R4 Zoning Review, Phase 2

ACS2020-PIE-EDP-0015

**Motion N° PLC 2020-29/1**

Map 58

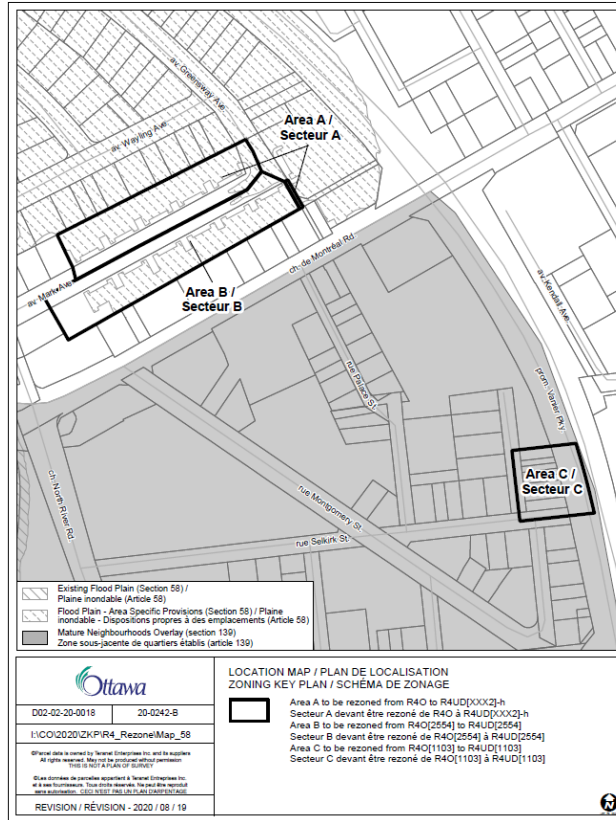
WHEREAS these errors include a missing Exception and holding symbol on certain lands on one of the Lands Affected maps; and

1. Amend the report number to ACS2020-PIE-EDP-0016
2. Amend Document 2a of the report by replacing Map 58 with the attached Map 58;
3. Amend Document 2a of the report by replacing Map 67 with the attached Map 67;
4. Amend Document 2a by adding the following as Recommendation 3d:
  - "(3d) Amend Table 137, Column 1, Row 12 by adding the words ", other than the R4-UA, R4-UB, R4-UC and R4-UD zones," after the words "In any R1 to R4 zone."

Map 67

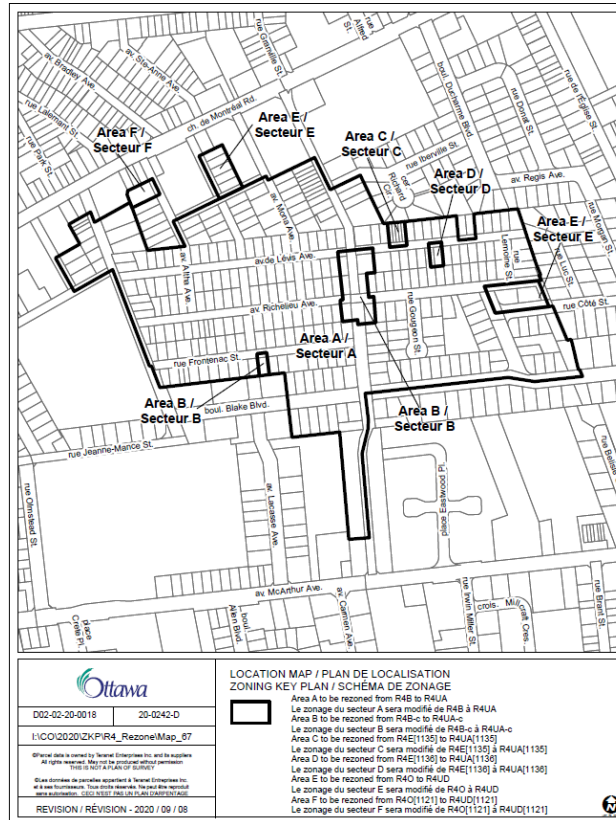
WHEREAS these errors include a label and legend item omitted from another of the Lands Affected maps; and
